BRIDGE No 37
PROJECT No BRF 030-2(17)S
ITEM No 621.74

TOWN OF JOHNSON, COUNTY OF LAMOILLE
BRIDGE RAILING FOR VT15 (MINOR ARTERIAL) OVER GHON RIVER
3L ALUMINUM APPROACH RAIL ~ MISC DETAILS

MADE CMS DATE 05/24/07 JOB No AR0395 CUST No
CHECK BLJ DATE 06/01/07 DRAWING LB16 (LAST) REV. No.

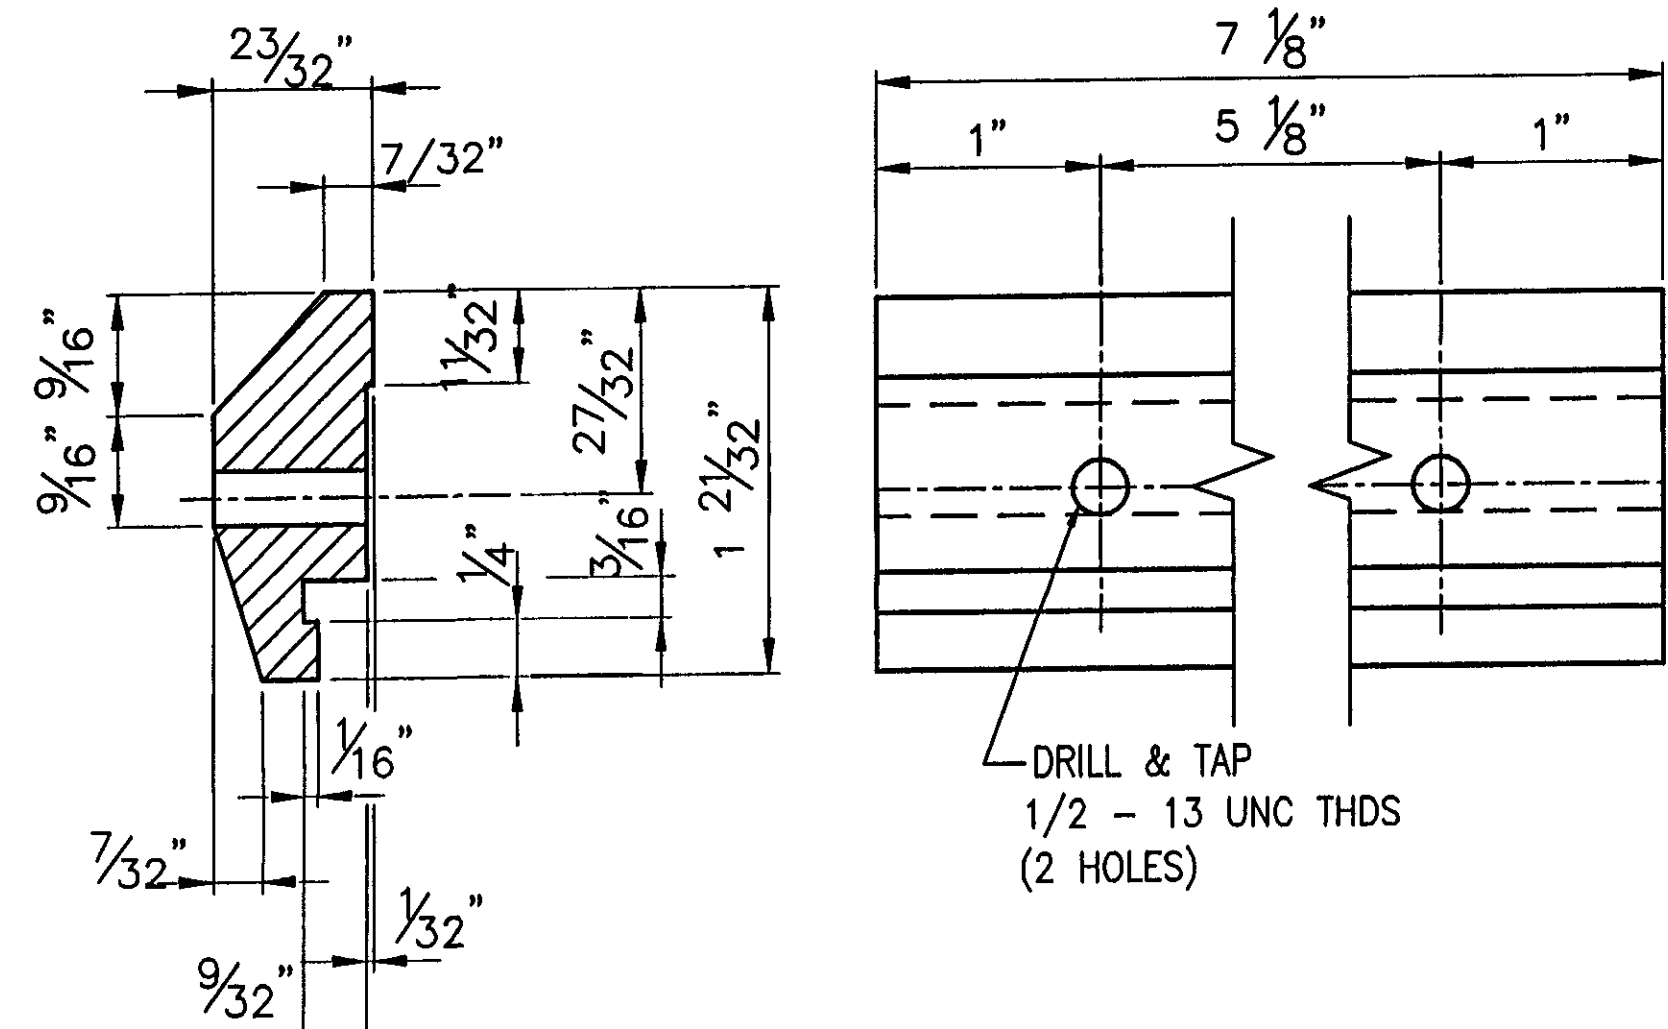
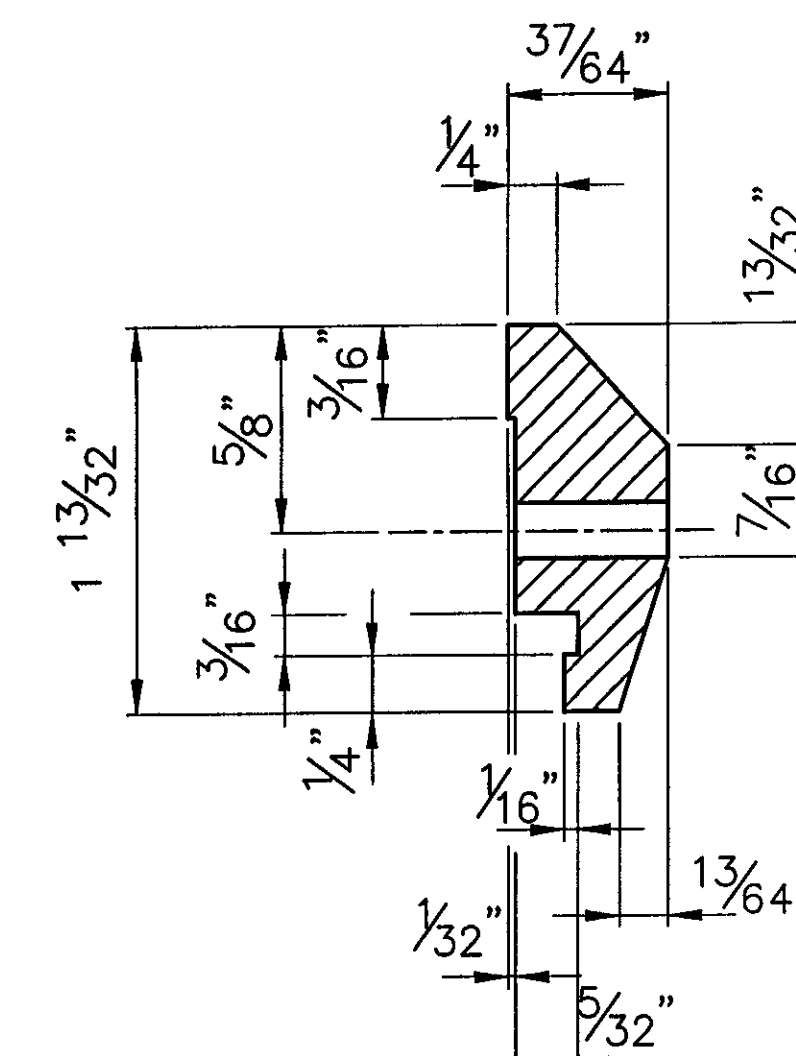
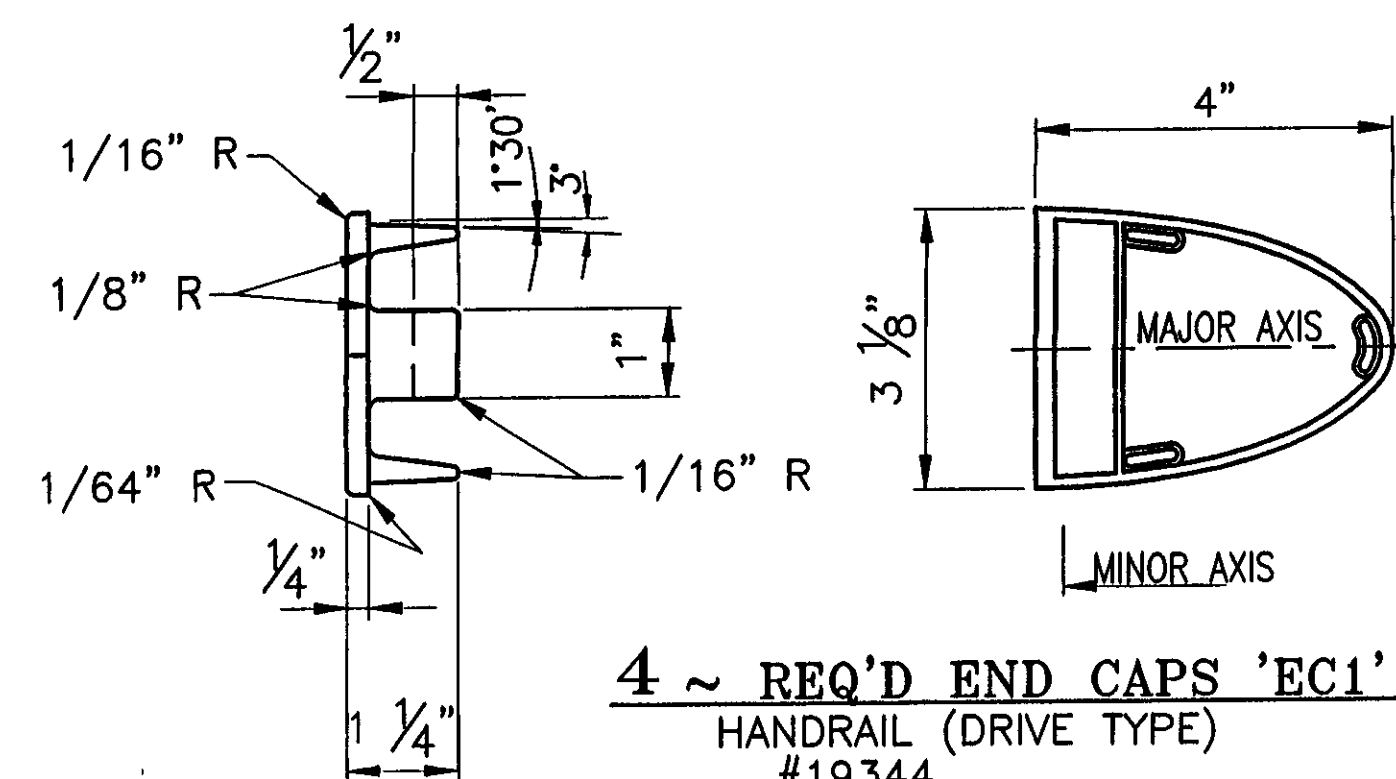
RECEIVED
OK'D BY CLD OK'D BY GAS
AUG 03 2007
RESUBMIT
BY KMH DATED 8/13/07
